UNITED STATES PATENT AND TRADEMARK OFFICE

APPLICATION NO.	FILING DATE	FIRST NAMED INVENTOR	ATTORNEY DOCKET NO.	CONFIRMATION NO.
10/720,313	11/24/2003	Peter Bernhardt	TRW(EHR)6873	4296

Office Action Summary

DETAILED ACTION

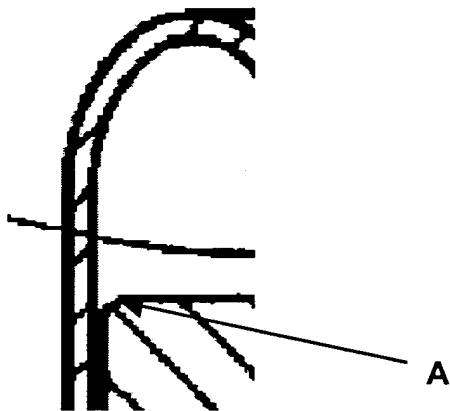
As to claim 4, Lavery et al. disclose a ball joint comprising:

a housing **220**;

a ball pin **114**;

a sealing bellows **240** which lies against the housing and the ball pin in order to seal between the housing and the ball pin; and

wherein the housing has a cylindrical section with a holding surface against which a sealing surface **258** of the sealing bellows lies, the cylindrical housing section adjoining a curved housing section, the curved housing section having a curved outer surface (curved at a portion **A**; Figure 2 reprinted below with annotations), the cylindrical housing section and the curved housing section being separated from each other by a step in the housing (Figure 2).

As to claim 5, Lavery et al. disclose a ball joint wherein the sealing bellows **240** includes a middle section that lies against the curved outer surface of the curved housing section and is retained by an interlocking fit (Figure 2).

As to claim 6, Lavery et al. disclose a ball joint comprising:

wherein the housing has a cylindrical holding surface against which a sealing surface **258** of the sealing bellows lies, the cylindrical holding surface being centered on the axis and extending axially, the cylindrical holding surface adjoining a radially outwardly extending step extending from one end of the cylindrical surface and defining a step surface, and the housing having a curved outer surface axially curved radially inwardly from the radially outer end of the step (curved at a portion **A**), the step being

located between and adjoining the cylindrical surface and the curved outer surface (Figure 2).

As to claim 7, Lavery et al. disclose a ball joint wherein the sealing bellows **240** includes a middle section that lies against the curved outer surface of the housing **220** and is retained by an interlocking fit (Figure 2).
